Access Compliance Report

(Curb Ramps)

Intersection ID: 12887	Main Street: CRAIGWOOD_DR	Cross Street: HICKORY_GROVE_RD	Location: NW
ADA ID: 0E1403C7E153	Ramp Type: Perp	Initial Pass/Fail: Fail	Overall Compliance: No
		Severity Score: 12.5

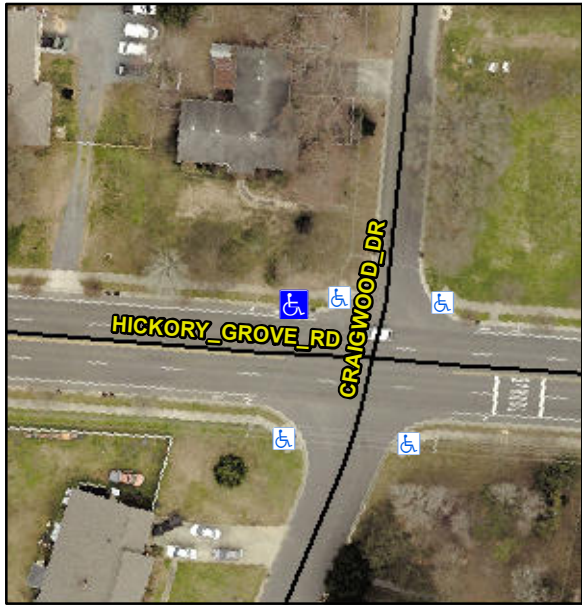
Codes/Mitigation Info/Possible Solution			Field Measurements/Component Compliance									
	Possible Solutions:		Compliance			Description			Data			
	Remove & Replace Entire Ramp.		N/A	Ramp Length (in)		48.5		No	Ramp Slope (%)		9.3	
			Yes	Ramp Width (in)		52.0		Yes	Ramp XSlope (%)		1.8	
			N/A	Flare Type LT		N/A		N/A	Flare Type RT		N/A	
			N/A	Flare Slope LT (%)		N/A		N/A	Flare Slope RT (%)		N/A	
			N/A	Flare Traversable LT?		N/A		N/A	Flare Traversable RT?		N/A	
			N/A	Landing Length (in)		N/A		N/A	DWS Provided?		N/A	
			N/A	Landing Width (in)		N/A		N/A	DWS Contrast?		N/A	
			N/A	Landing Slope (%)		N/A		N/A	DWS Length (in)		N/A	
			N/A	Landing X Slope (%)		N/A		N/A	DWS Full Width?		N/A	
Surveyor Notes:		N/A			N/A			DWS Offset (in)			N/A	
PROW/ADA:		R304.2.2			N/A							
					N/A			Gutter Ponding?			N/A	
					N/A			Gutter Lip Ht (in)			N/A	
					N/A			Painted X Walk1?			No	
					To S			X Walk 2 Direction			N/A

N/A			X Walk 2 Width (in)			N/A	
					2.6			X Walk 2 Slope (%)			N/A	
					1.3			X Walk 2 X Slope (%)			N/A	
					N/A			Ramp inside XWalk2?			N/A	
					N/A			Clear Space?			N/A	
					N/A			Clear Space to XWalk (in)			N/A	
					N/A			Storm Grate/Utility Hazard?			N/A	
								Storm Grate/Utility Type				
					N/A						N/A	
								Yes			Surface Condition? (G/P)	
											Good
